# Murphy Creek and Tributaries Major Drainageway Plan

## BASELINE HYDROLOGY REPORT

REVISED APRIL 2023

### TABLE A-1 Response to Draft Baseline Hydrology Report Comments

FIGURE B-1 Interactive Hydrology Map

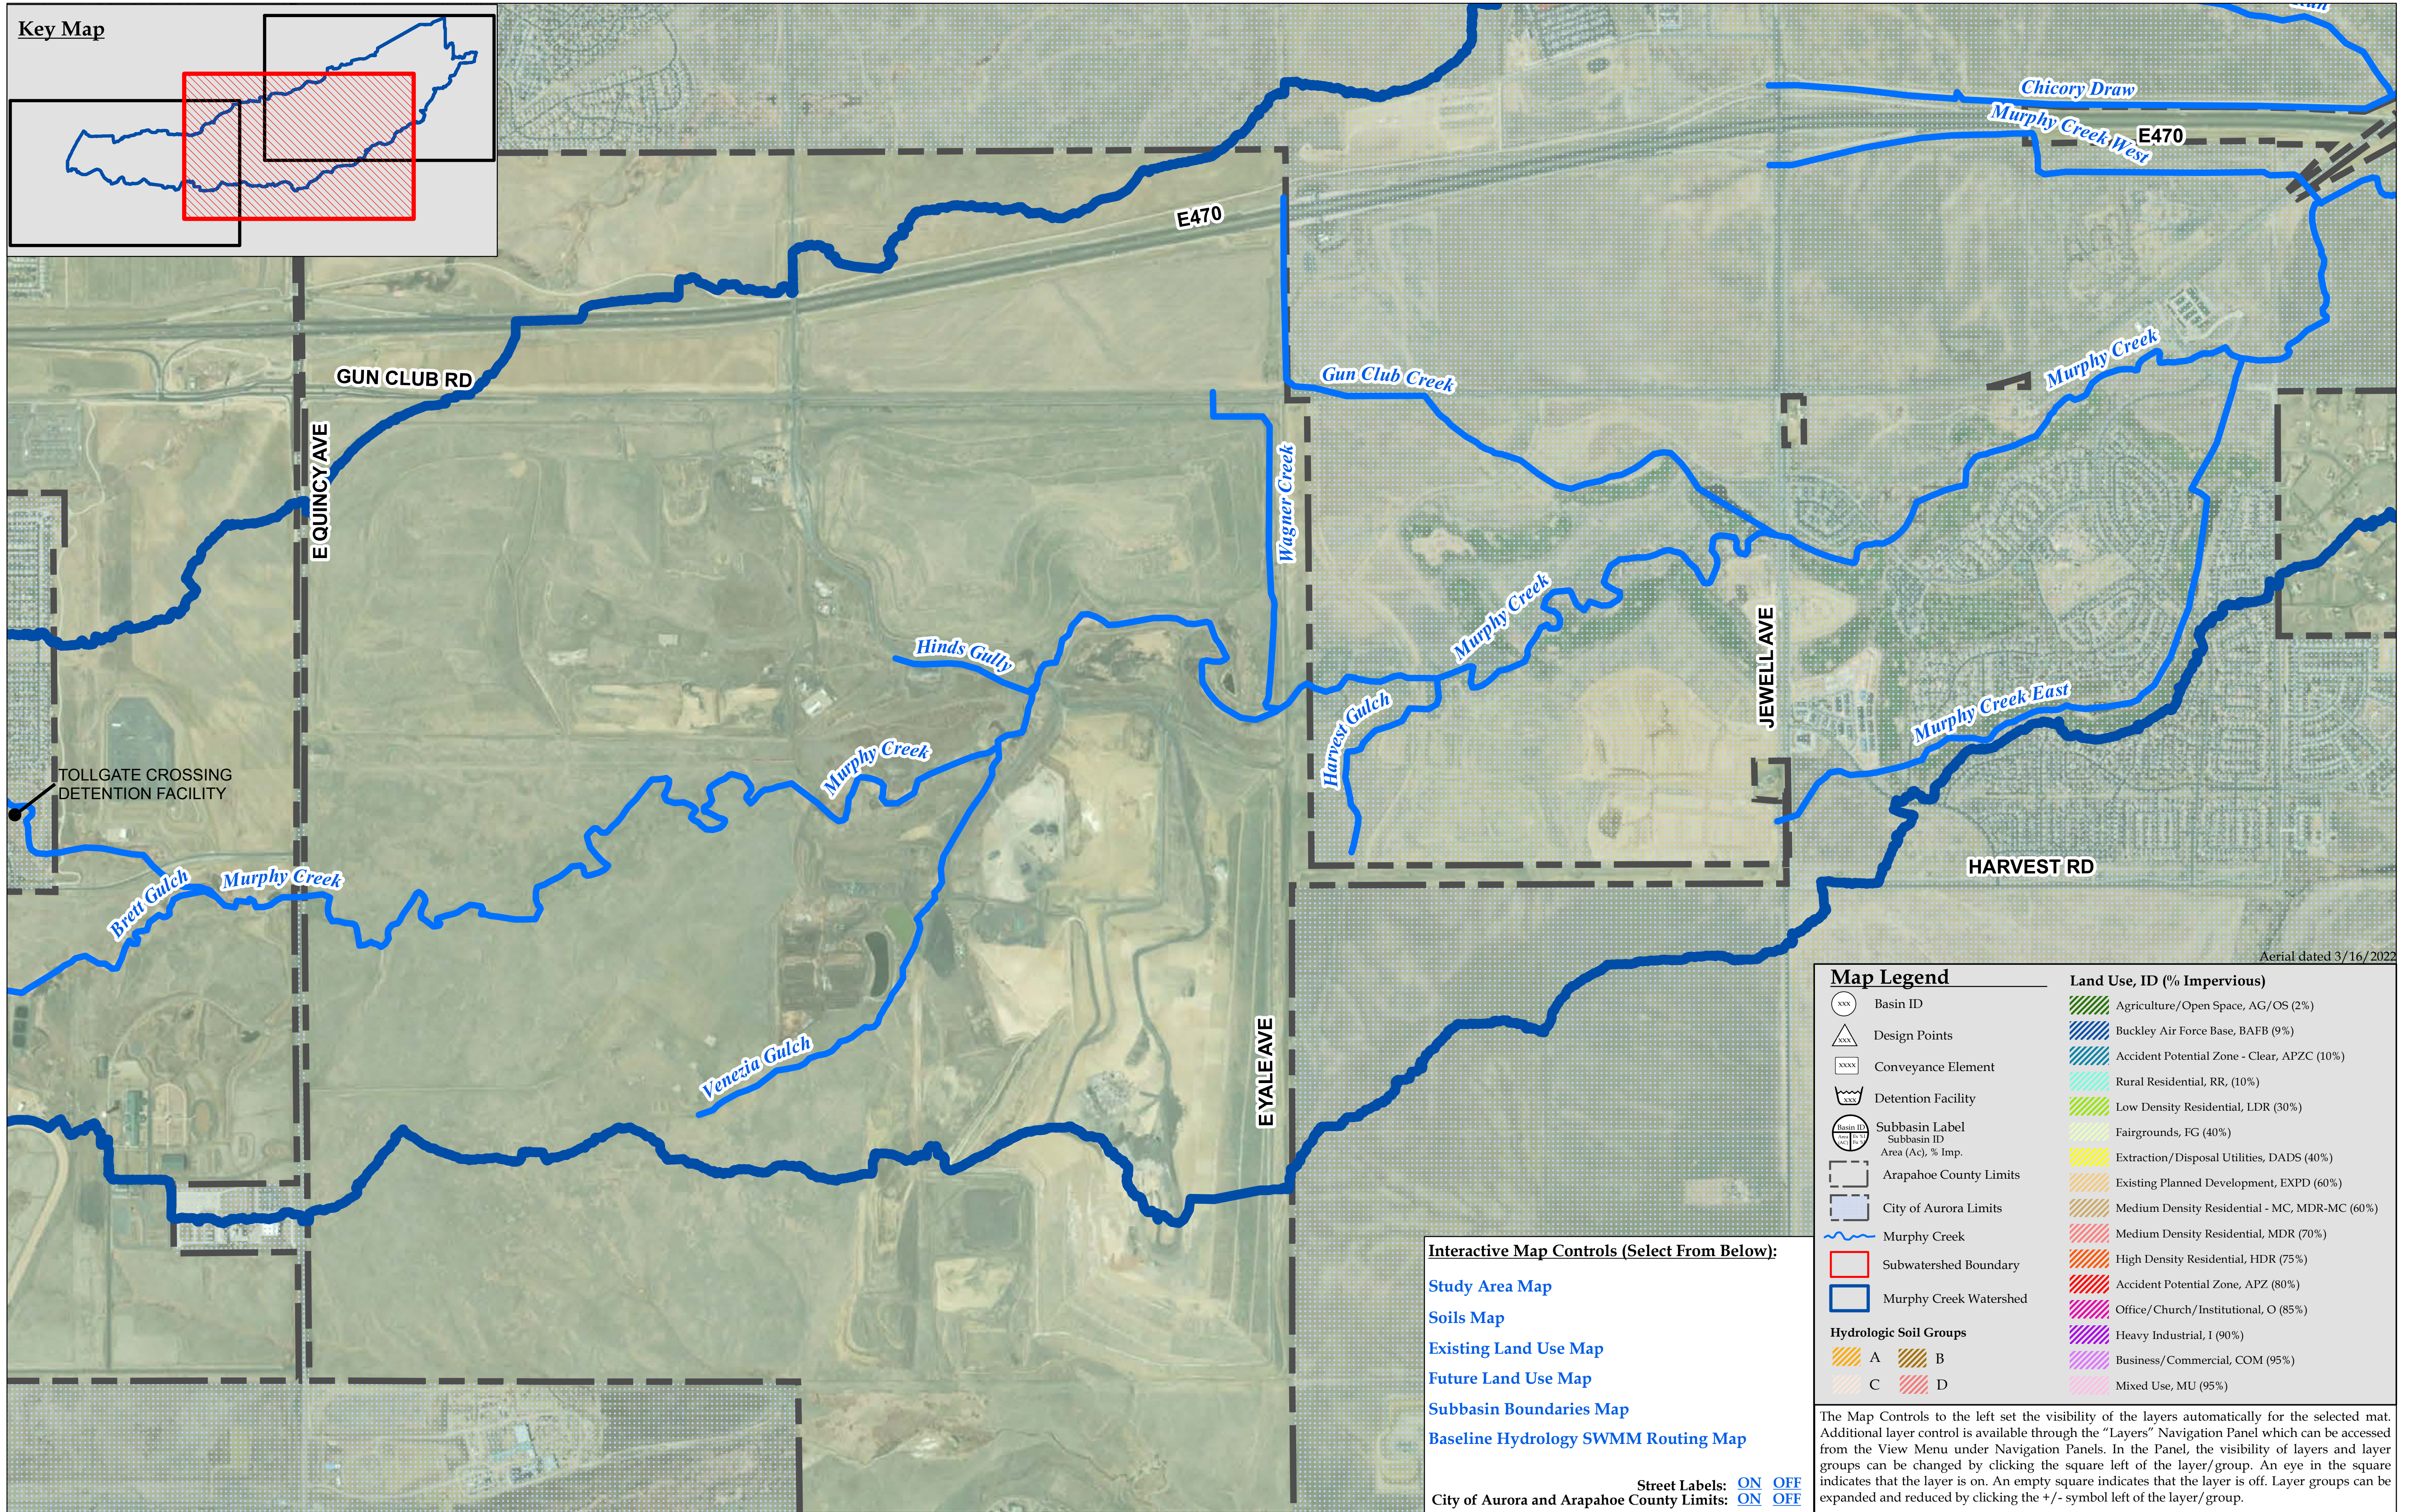
62	19	tclark	References comment 1.	Agree	See comment response 1.	9/8/2022
63	19	tclark	identify or label the remainder area as Unincorporated Arapahoe County (update on all maps)	Agree	Arapahoe County has been added to the legend.	9/8/2022
64	19	tclark	see comment on next sheet and revise accordingly	Agree	See comment 12 response.	9/19/2022
65	19	chaggerty	Why so small [Subcatchment 150.1]?	Agree	Subcatchment 150.1 has been included as part of subcatchments 700 and 153.	9/8/2022
66	19	chaggerty	Crossing Culvert [at Quincy Ave - Subcatchment 650]?	No action	This crossing was not surveyed, but aerial imagery suggests a culvert at this location and routing matches the 2008 OSP.	9/7/2022
67	19	dclark	Label Southlands Detention	Agree	Southlands Detention Basin has been labeled.	9/12/2022
68	19	dclark	Label tollgate crossing detention		Tolgate Crossing Detention Basin has been labeled.	9/12/2022
69	19	HEDC62 - SPL	Include the legend for Unincorporated Arapahoe County	Agree	See comment 63 response.	9/12/2022

Comment Number	Page Label	Author	Comments	Merrick Action	Merrick Response	Response Date
99	25	HEDC62 - SPL	RR-C, Rural Residential C	Agree	Table B-2 has been updated.	9/7/2022
100	26	jtraynor	These should match Figure B-1	Agree	Map label source has been remedied accordingly as part of imperviousness updates. Additional significant figures are provided in the table where there is additional space.	9/19/2022
101	26	tclark	evaluate basins to meet ongoing Arapahoe County rezoning application. Update all other calculations, text, etc... accordingly.	Agree	See comment 12 response.	9/12/2022
102	26	HEDC62 - SPL	What does this mean - lowest area in the basin?	No action	Depression losses are based on land cover. Referencing Table 6-6 in the USDCM, each subwatershed was given a pervious depression storage value of either 0.35 inches for subwatershed imperviousness values greater than 15%, or 0.4 inches for less than 15%.	9/19/2022
